CITY PROJECT NO. 14922
CONTRACT NO. 9807

ADDENDUM 1: TAC 6/23/2026
REPLACE SHEETS:
COVER, U1, & U2

FORDEM AVE - FIRST STREET RELIEF SEWER

14922	MADISON, WI	9807	U-1
PLAN & PROFILE - SANITARY REPLACEMENT		FORDEM AVE - FIRST STREET RELIEF SEWER	
14922		U-1

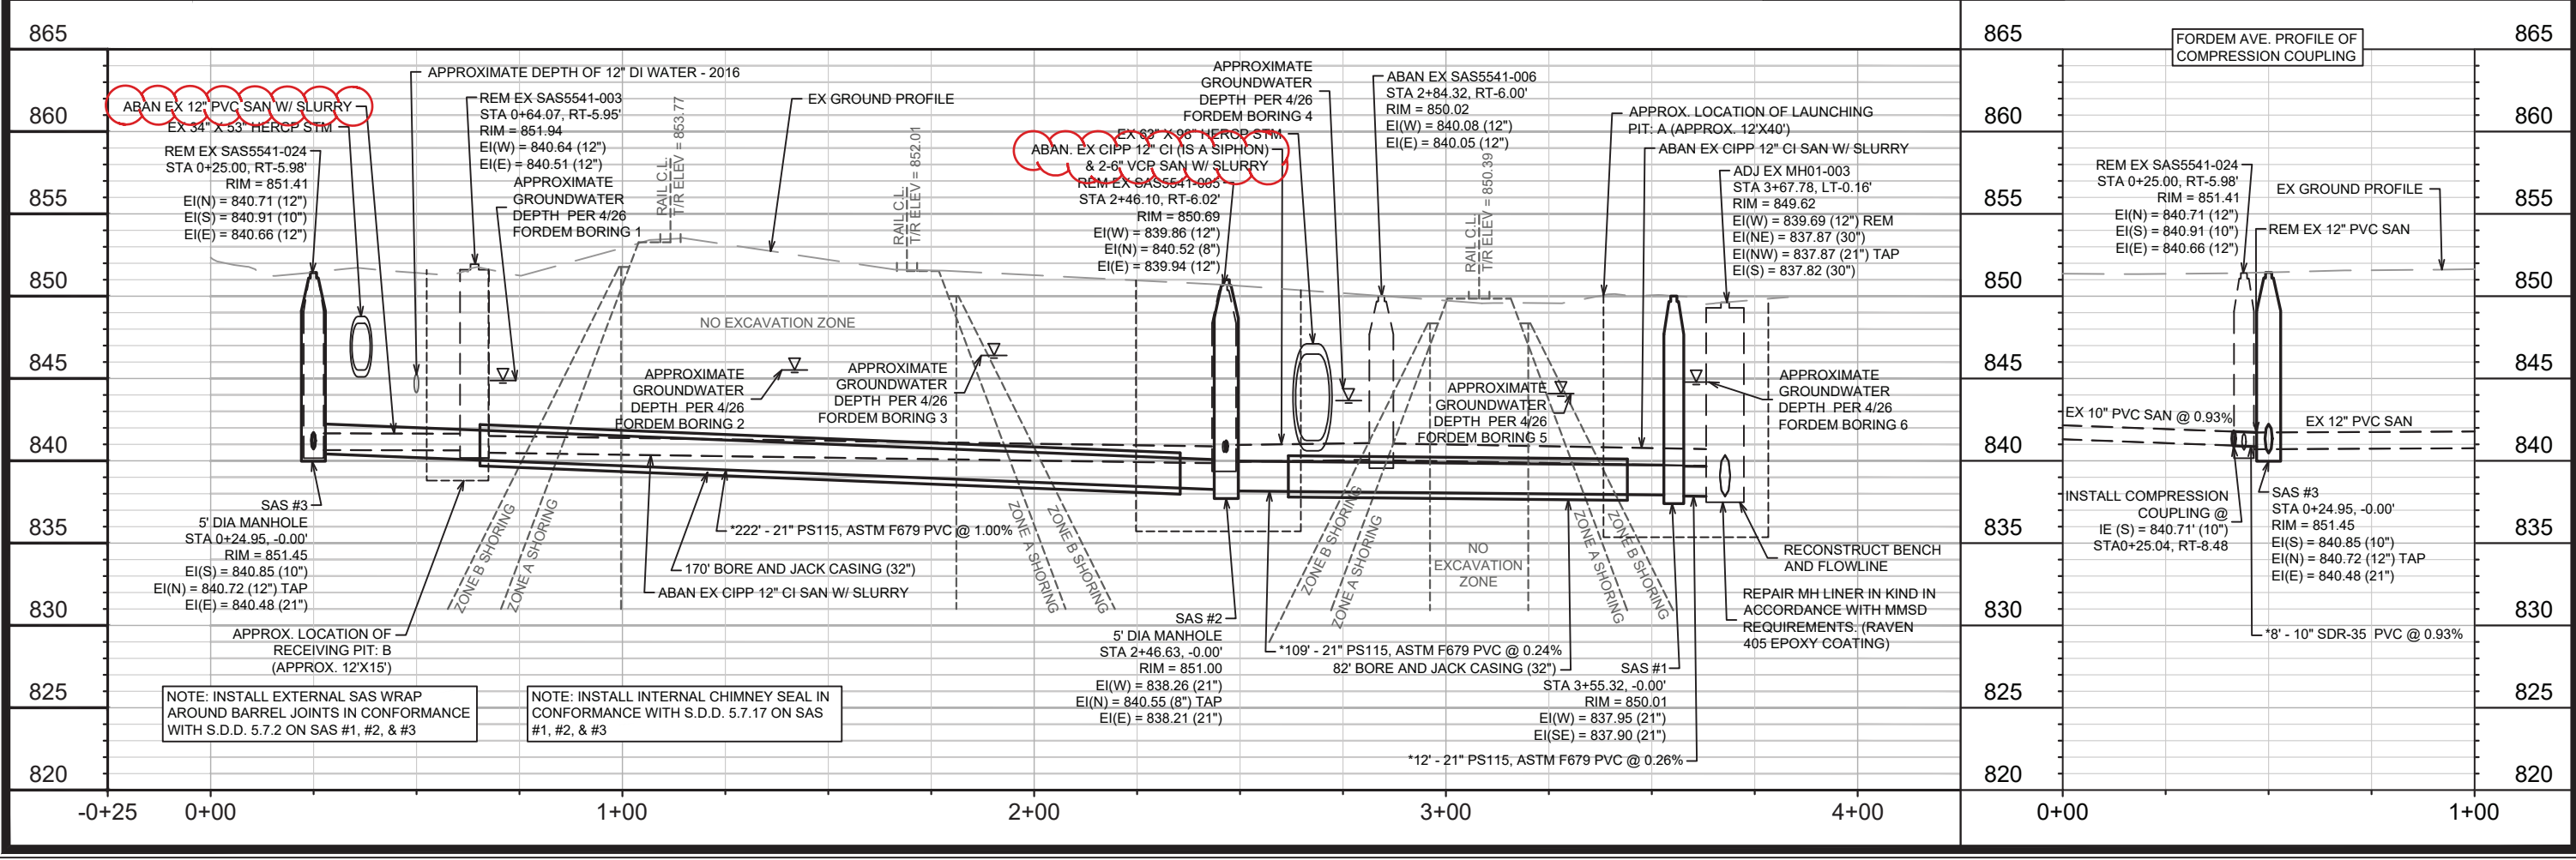
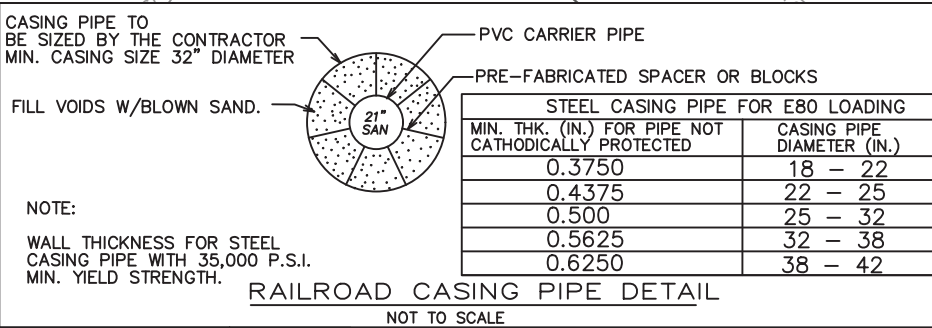
ADDENDUM 1 TAC 6/23/2026
REMOVE PIPE REPLACED WITH
ABANDON PIPE WITH SLURRY
